**SOILS AND GEOLOGY STUDY  
MONUMENT RIDGE EAST  
MONUMENT HILL ROAD AND PALMER DIVIDE ROAD  
EL PASO COUNTY, COLORADO**

**PCD No. SP241**

Re: Response to Review Comments  
Monument Ridge East  
Monument Hill Road and Palmer Divide Road  
El Paso, Colorado  
Entech Job No. 230248

FIG. 7

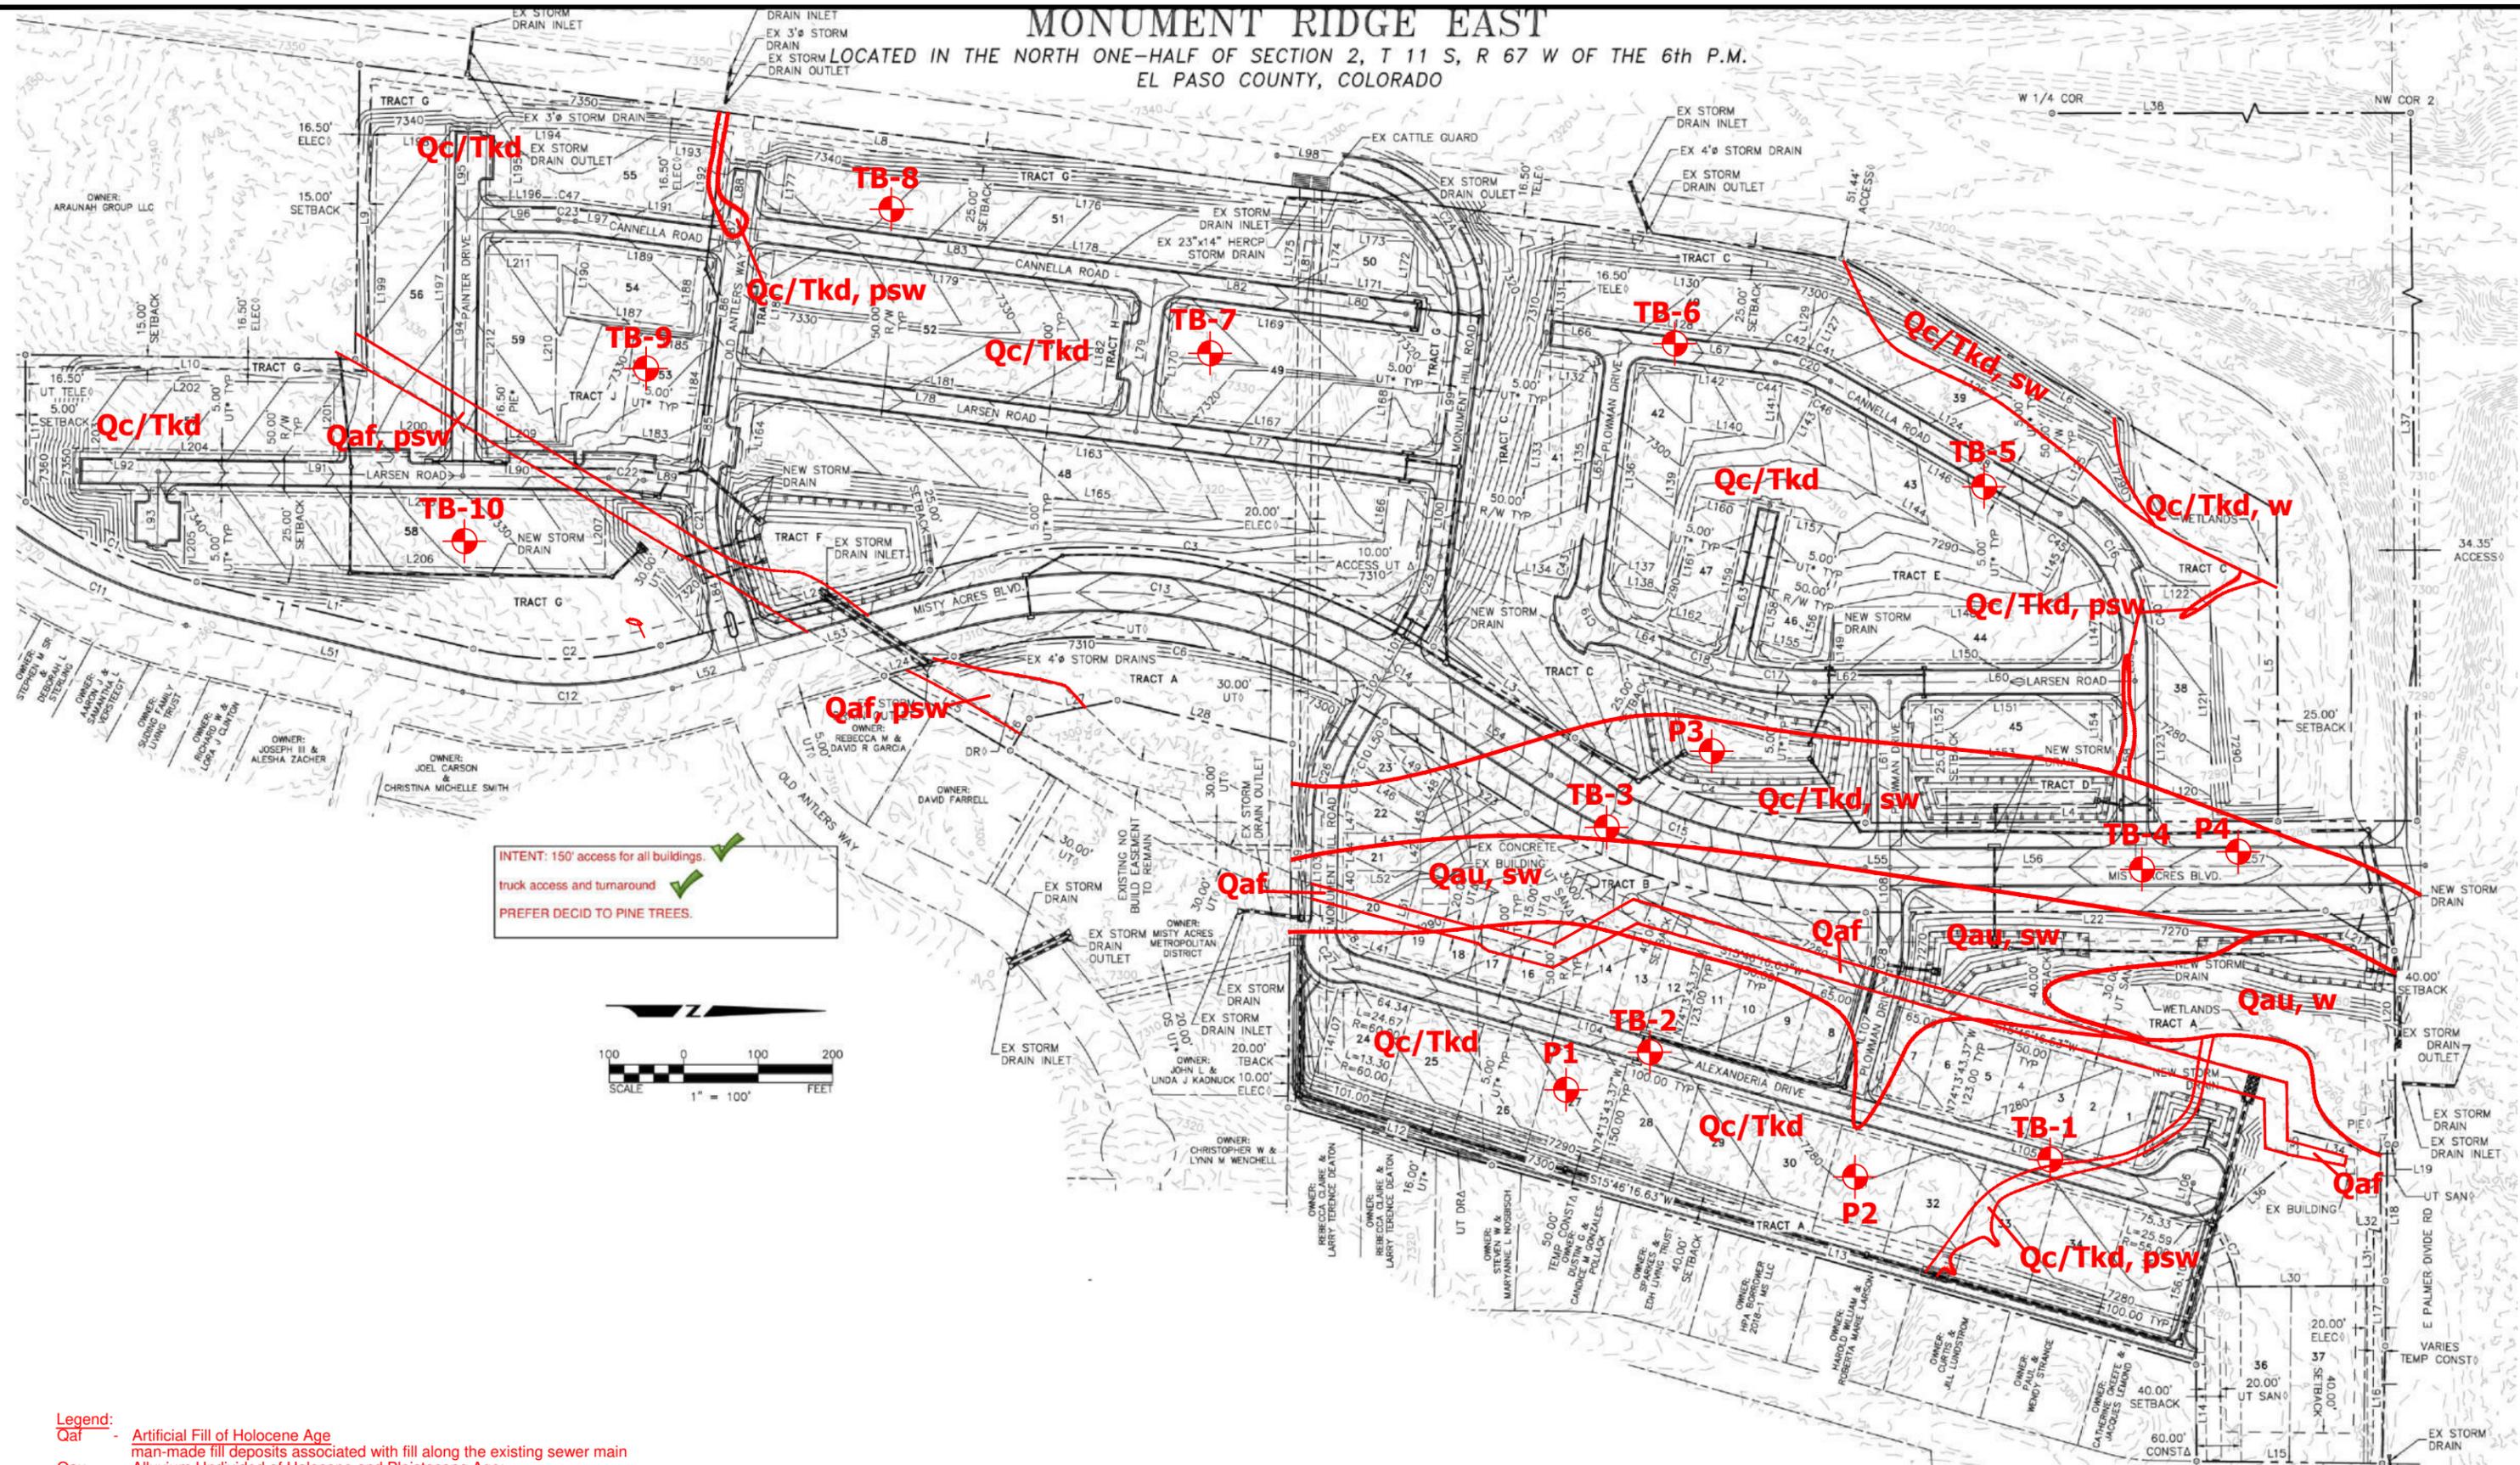
1. Entech encountered groundwater at depths ranging from 1 to 10 feet during drilling. However, figure 7 of their report fails to depict this shallow groundwater in the relevant areas. Test Boring No. 3, which includes groundwater at 1 foot, is mapped as Colluvium and Dawson Formation without shallow groundwater. It is imperative that Figure 7 is revised to reflect the geologic hazards and constraints.

4. A geologic hazard note is not included in the preliminary plan drawings. CGS recommends updating Figure 7 of Entech’s report and adding a note to the preliminary plan/plat listing the geologic hazards and constraints, along with mitigation measures.

5. Wetlands (Freshwater Emergent/Freshwater Forested/Shrub Wetland) are located within the site. However, these areas do not appear to be portrayed correctly in Figure 7 of Entech’s report. These areas are associated with standing water; lots should not be located within these areas, a setback should be established, and these areas should be designated as “No Build Areas”. Setbacks and no build areas should be noted on the plans.

**Entech Response to Comment 1:** The Geology/Engineering Geology Map has been updated and is included with the revised report.

**Entech Response to Comment 4:** Figure 7 has been updated, and a geologic hazard note provided for the preliminary plan/plat.
